Parts Bulletin

Recall RP1044: Polestar 2 Far Side Airbag

NO:
RP1044

DRIVER SEAT

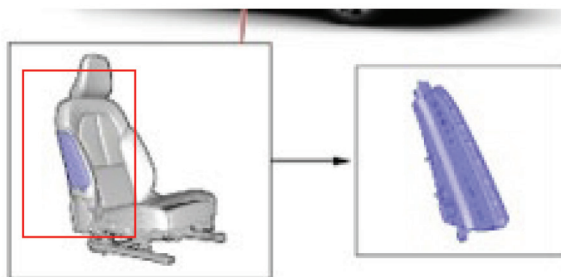
Polestar investigations has determined that the supplier's assembly station had incorrect software control parameters that caused the clamps on the driver side inner Far Side Airbag (FSAB) to not be crimped properly.

As a result, in the event of a crash, the driver side inner FSAB may not deploy correctly, increasing the risk of injury.

To remedy the concerned vehicles, Polestar will replace the inner FSAB in the driver front seat.
